BULLETIN

NUMBER 43

SUBJECT: Stabilizer Link Tube and Rear Support Bearing Bracket

MODELS AFFECTED: J3, Serial Nos. 2325, 2327, 2339, 2340, 2342, 2344, 2345, 2347, 2349, 2351, 2355 and up to 8018.

Instructions for Drilling Oil Holes

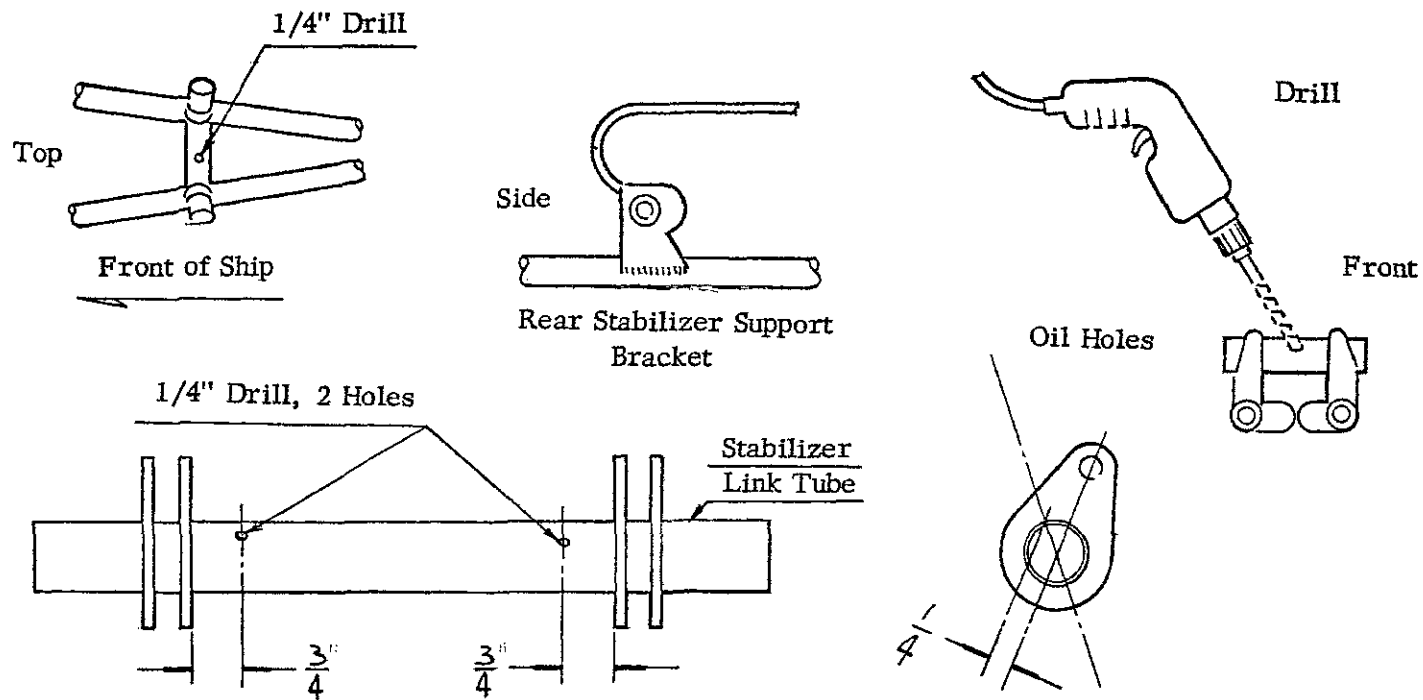
3. Defective parts should be replaced.
4. Before reassembling the parts, a 1/4" oil hole should be drilled in the top center of the stabilizer rear support bearing tube and also 3/4" inboard of each attachment lug on the link tube as shown on the attached sketch unless such holes are already present.

If an extension drill is not available to drill the oil hole in the stabilizer rear support bracket, a $\frac{3}{16}$ " hole may be drilled at an angle, as shown and slightly to the rear of the top center if necessary.

An extension drill may be made by brazing a $\frac{1}{4}$ " drill to a length of $\frac{1}{4}$ " cold roll steel rod.
